ADDENDUM NO. 2

Venetia Valley TK-8 School Landscape Renovations

Project Number #25-03

Addendum Date: March 20, 2025

SHEET NUMBER
ADDENDUM 2
L3.2

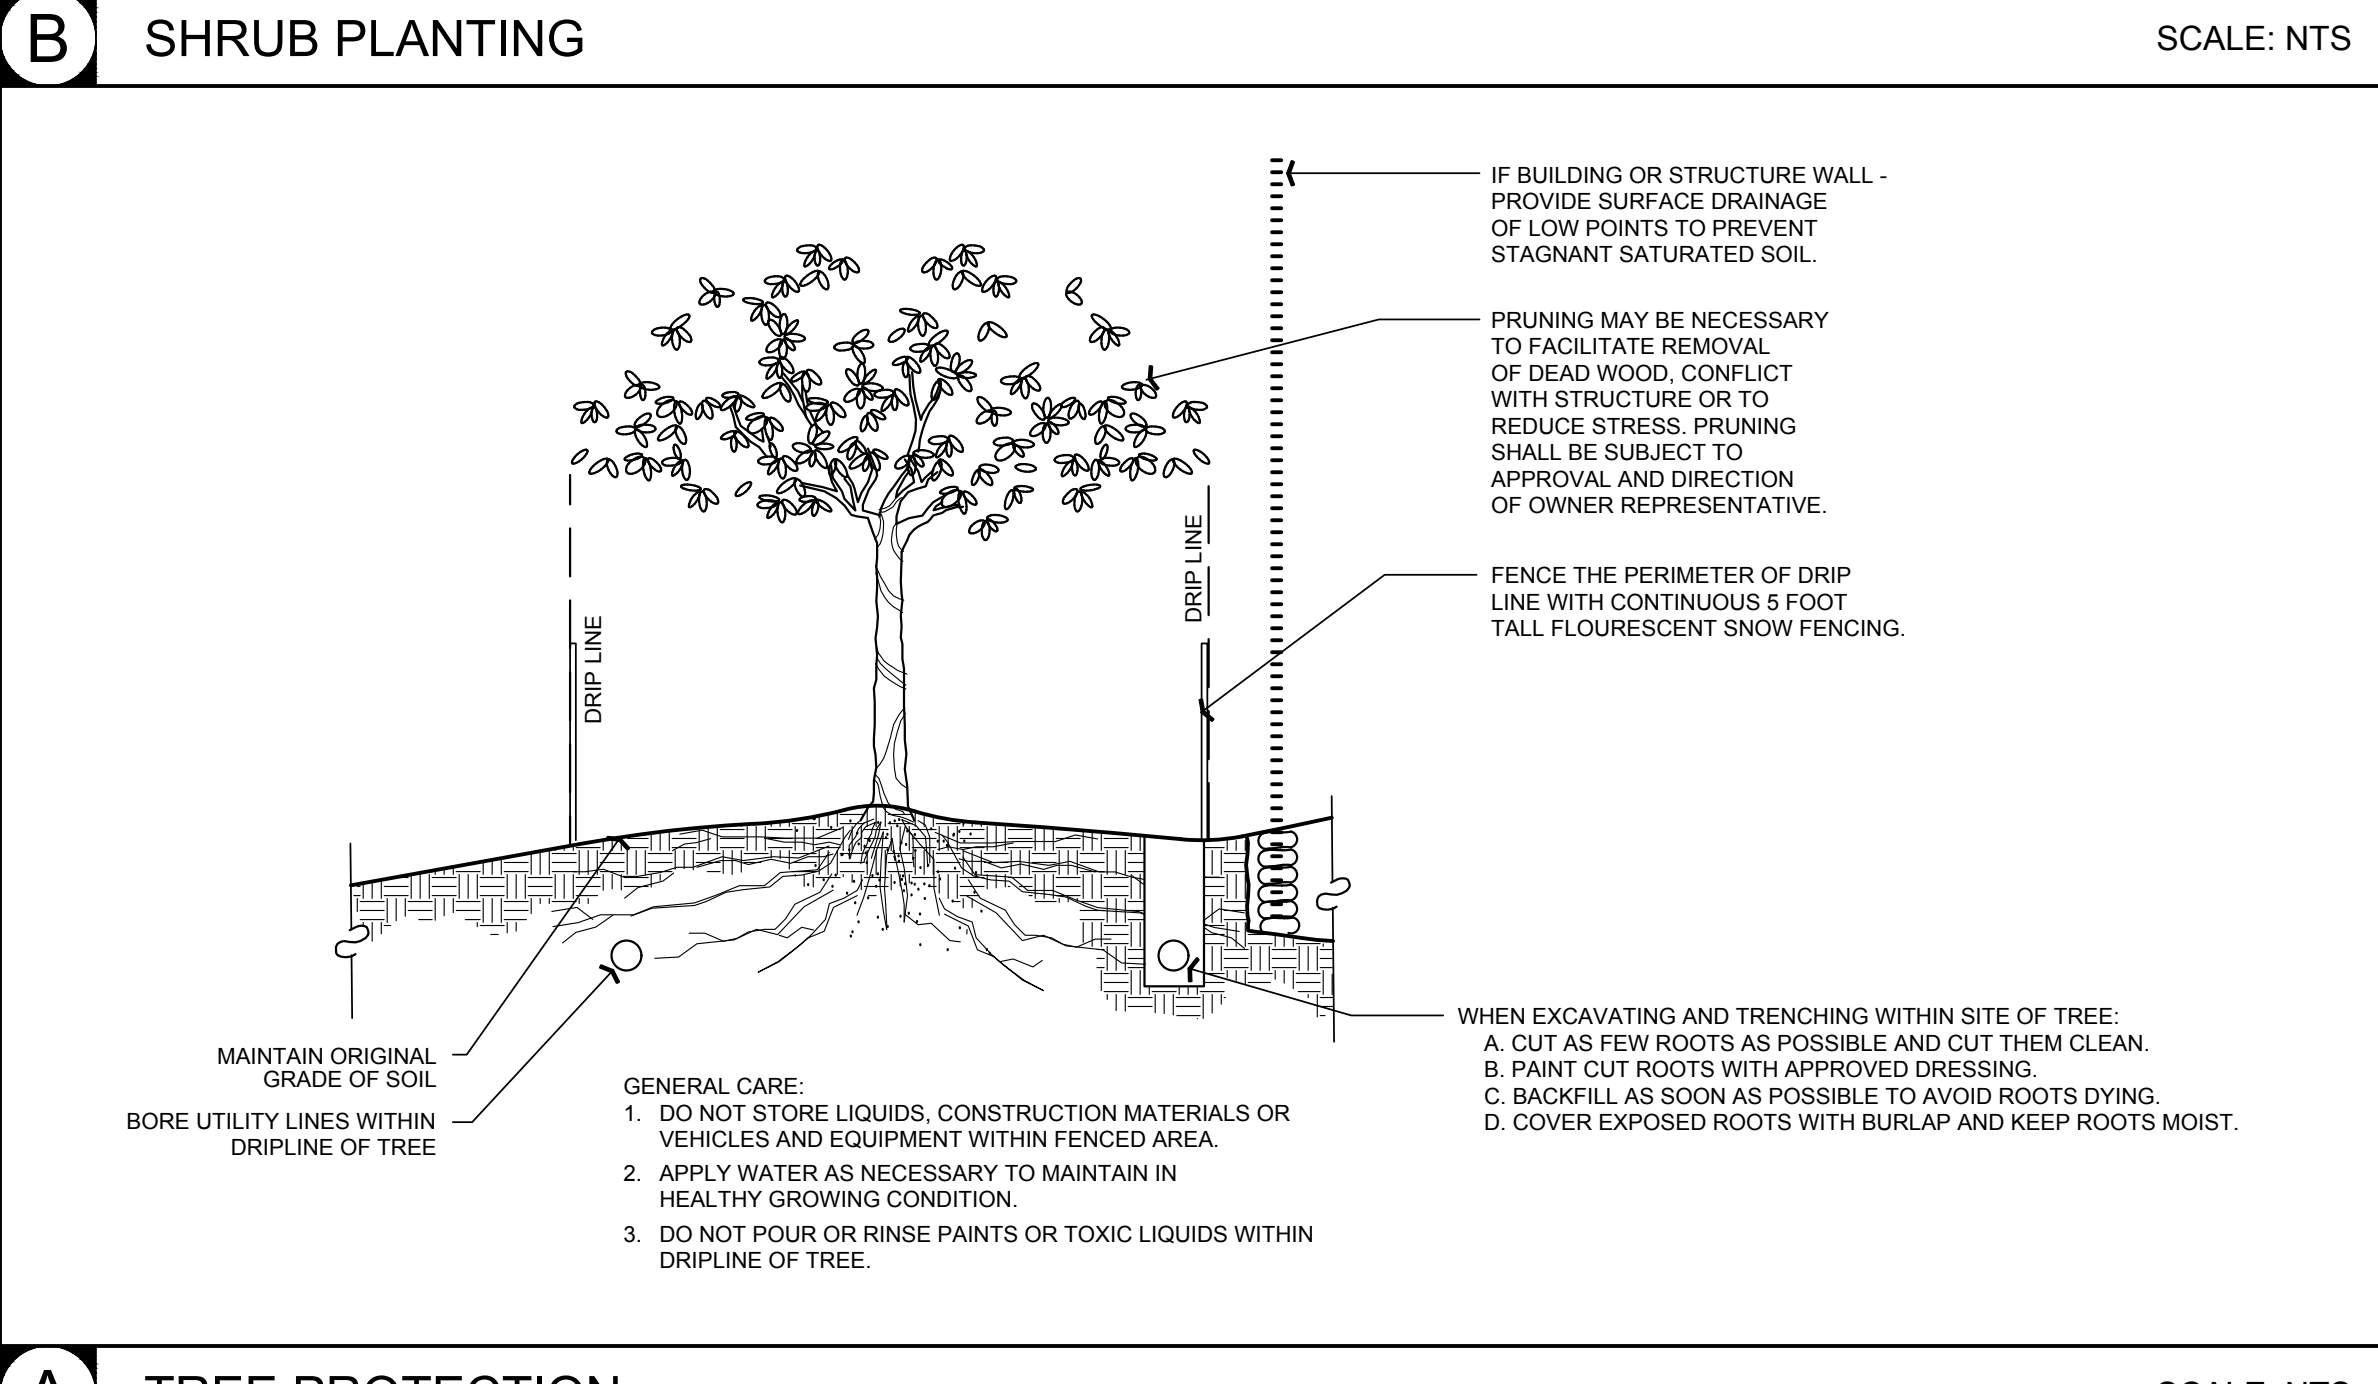
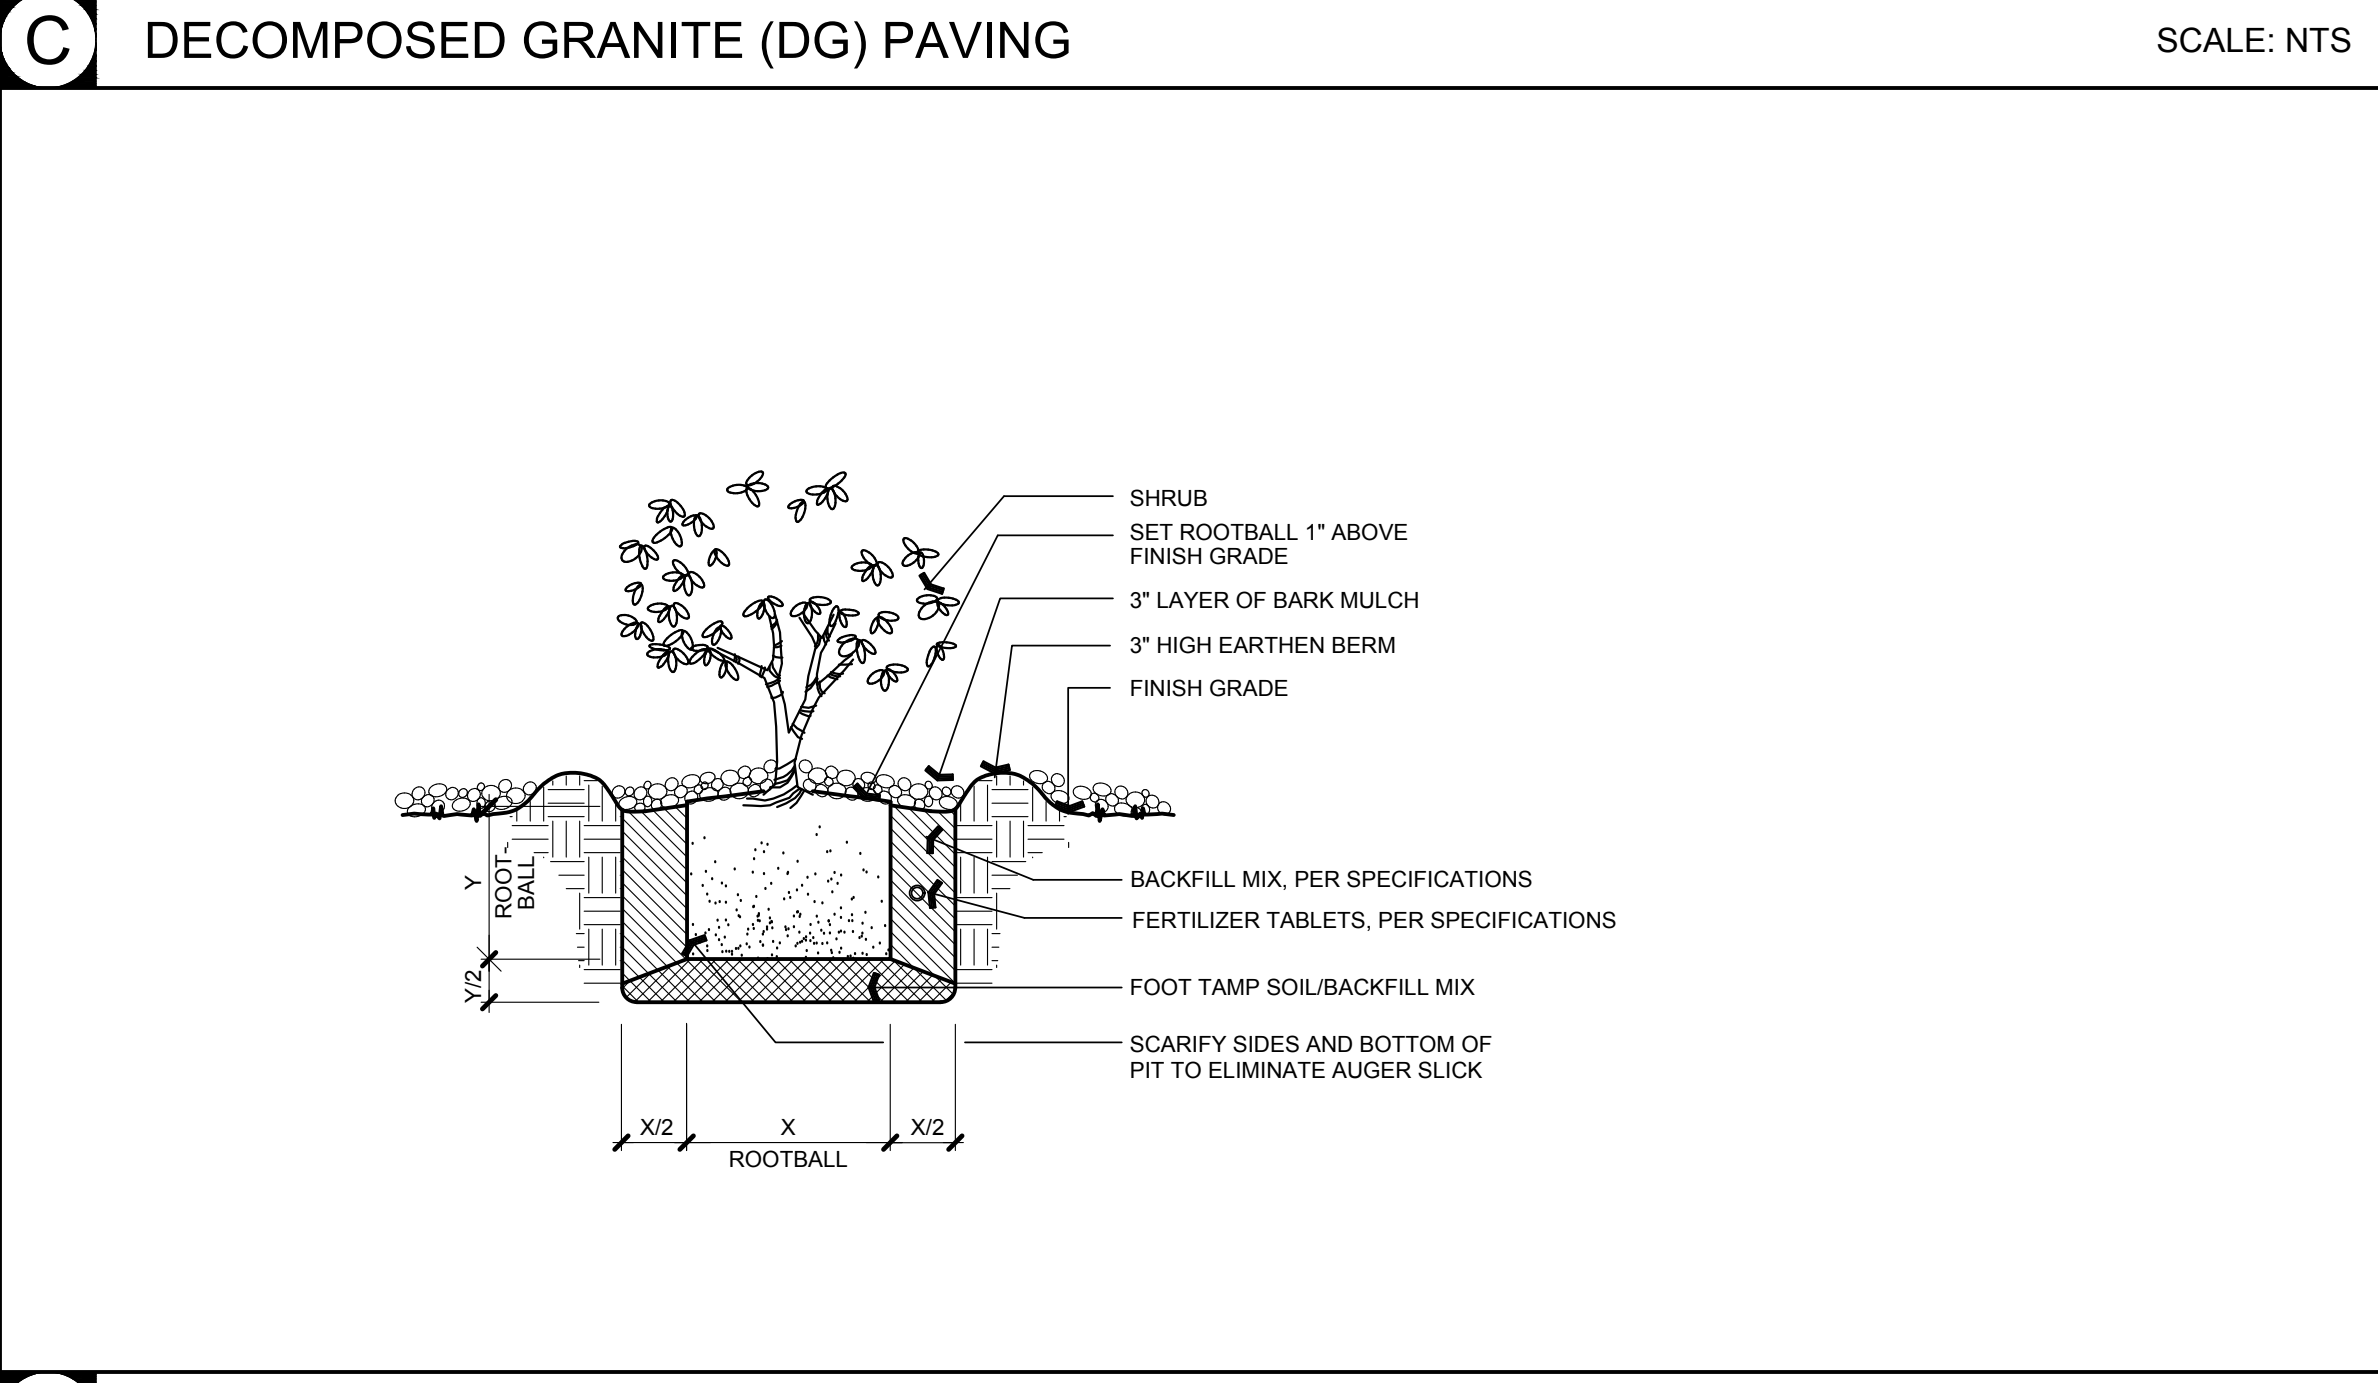
- a. Answer: Synthetic turf shall be Playground Grass ‘Quest’, a ForeverLawn product, available through Ross Recreation.
10. Question Received: **“Reference to sheet L3.2, rotor is 1-20-06-PRB-R-MPR, but this model is not available. Please confirm rotor is I-20-06-PRB-R-MPR.”**

18. Question Received: “Please confirm we can use existing wire for a new remote-control valve closed in building L1 middle school shown in sheet L3.2.”

19. Question Received: “Reference to sheet L3.08B, remote control valves closed to field area are H controller station but the call-out shows B controller station. Please clarify.”

ITEM NO. 1.5: SHEET L3.2 IRRIGATION PLAN:

Revise: Irrigation legend to include graphics for (E) SCH 40 PVC SLEEVES TO REMAIN.

Add: Callout to clarify location of (2) new irrigation lateral lines installed in sleeves that are to be installed via direct bore under existing paving to remain.

- a. Answer: Correct, rotor is to be I-20-06-PRB-R-MPR.
11. Question Received: **“Reference to sheet L1.1 in addendum #1, concrete paving shall be installed per detail C/L2.2, but detail C/L2.2 is asphalt paving. Please confirm concrete paving shall be bid as detail C/L2.1.”**

- a. Answer: Confirmed. The existing control wire for the valve adjacent to the middle school area is to be re-used.

- a. Answer: The 'H' or 'L' designations on the record drawings are in reference to the hydrozone type (H is for high water use, L is for low water use). All of the valves in the turf field areas function from Irrigation Controller 'B' as is labeled on sheet L3.2.

Replace: Sheet L3.2 in its entirety with the attached sheet Addendum 1-L3.2.
